**Water Right Conditions  
Tracking Slip**

**File No:** G-17298

**PUBLIC INTEREST REVIEW FOR GROUND WATER APPLICATIONS**

**TO:** Water Rights Section Date 25 February 2010  
**FROM:** Ground Water/Hydrology Section Gerald H. Grondin  
Reviewer's Name  
**SUBJECT:** Application G- 17298 Supersedes review of \_\_\_\_\_  
Date of Review(s) \_\_\_\_\_

Hydrograph for State Well KLAM 50493

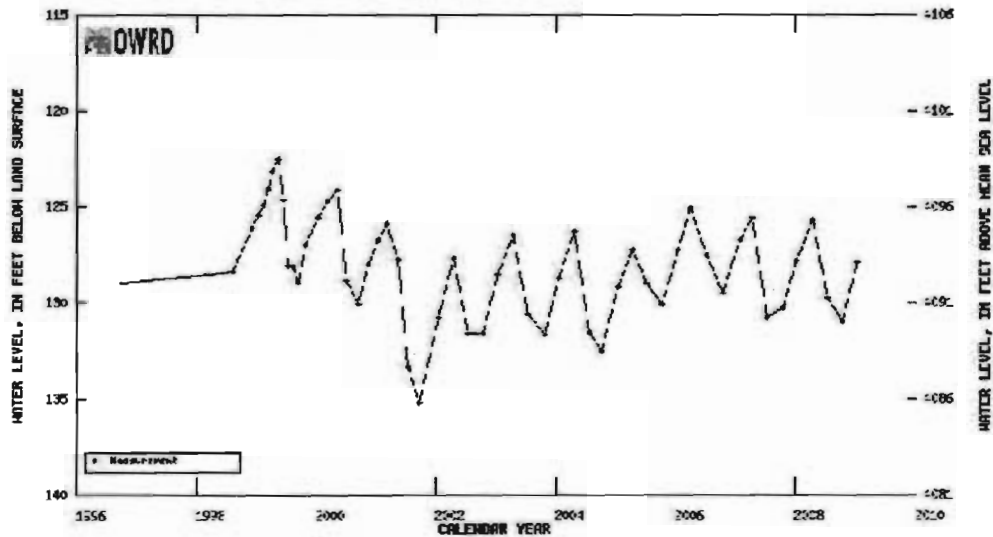
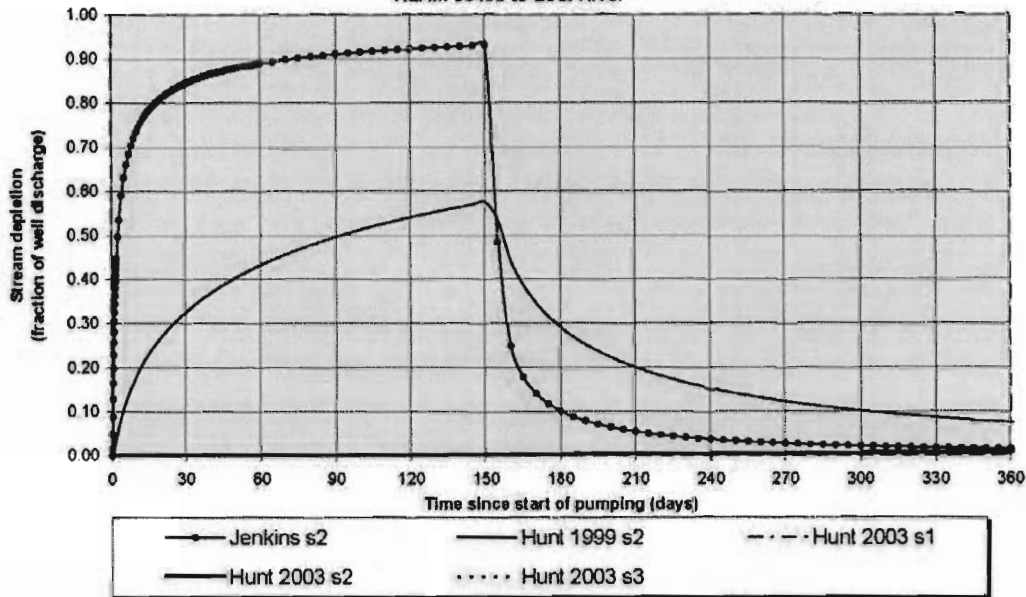
Additionally, there are OWRD ground water level measurements at the proposed well (KLAM 50493) from 1998 through 2009. The hydrograph also shows both long-term climate influences and short-term (seasonal) ground water pumping influences. For the period represented, the water level elevations and variability on this hydrograph are similar to those for state observation well 285 (KLAM 12221).
